# PREVOST

## Warranty Bulletin

95-15

Date: April 1995  
Section: 06  
Subject: Upper Windshields Wipers  
Application:

FIGURE 1

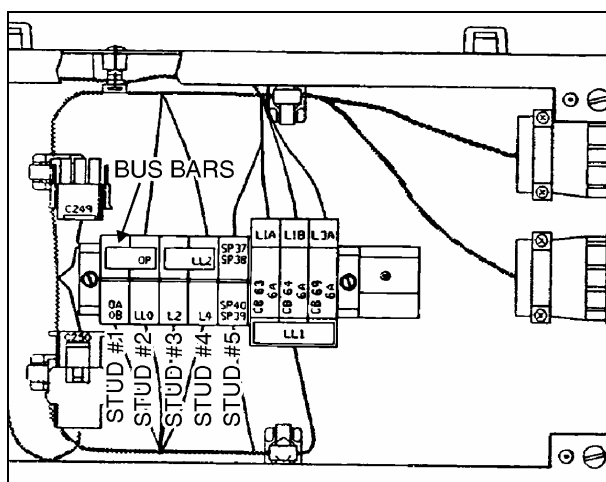
On the above-mentioned vehicles, a problem may affect intermittent mode on upper windshields wipers. This problem is caused by a poor ground. If you have experienced this problem on your vehicle, we recommend you to correct it as per the following procedure.

1. In front service compartment, open alarm junction box.
2. Remove the bus bars on studs #1 and #2 (Fig.1).
